This technical bulletin only applies to RPK4-FD2101 kits that have harness with label FD2A-RS-HAR included.

Issue:

STEP 1

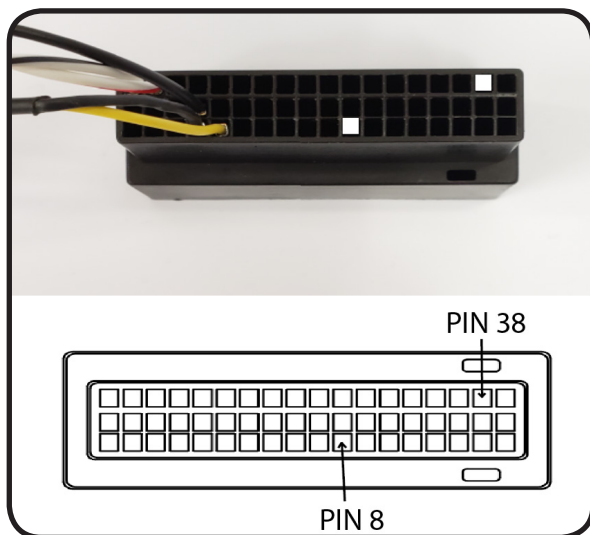
Factory USB port is no longer powered or functional upon removing the factory radio.

IDENTIFY THE RECEPTACLES YOU WILL BE ADDING PINS INTO ON THE 54-PIN CONNECTOR.

By using the crimped wires included, insert pins into two of the receptacles in the 54-pin connector (pins 8 & 38) that are used to supply +12V and Ground to the factory USB port, thus making it functional once again.

STEP 3

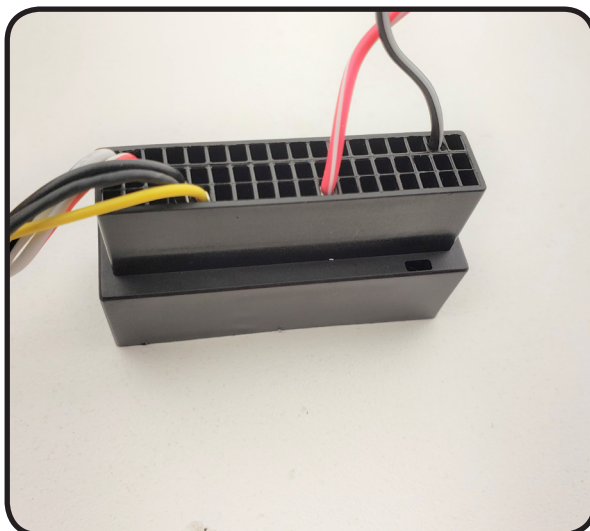
ENSURE PINS ARE SEATED FIRMLY INTO POSITION. PINS WILL “CLICK” INTO THE RECEPTACLE.

STEP 2

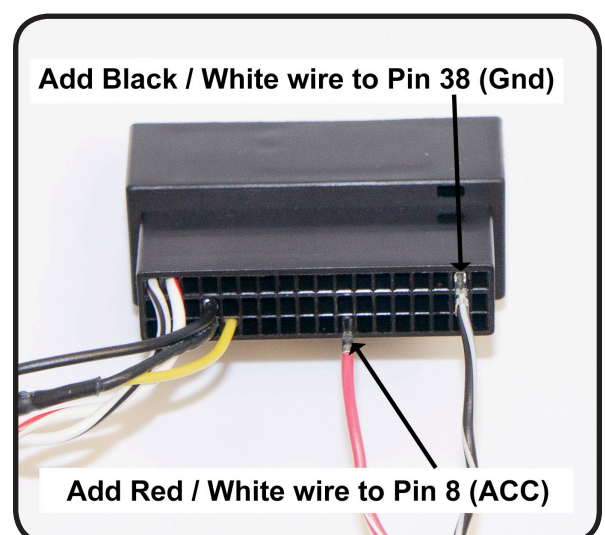
INSERT PINS INTO RECEPTACLES 8 AND 38 WITH LOCKING TABS FACING EDGE OF CONNECTOR.
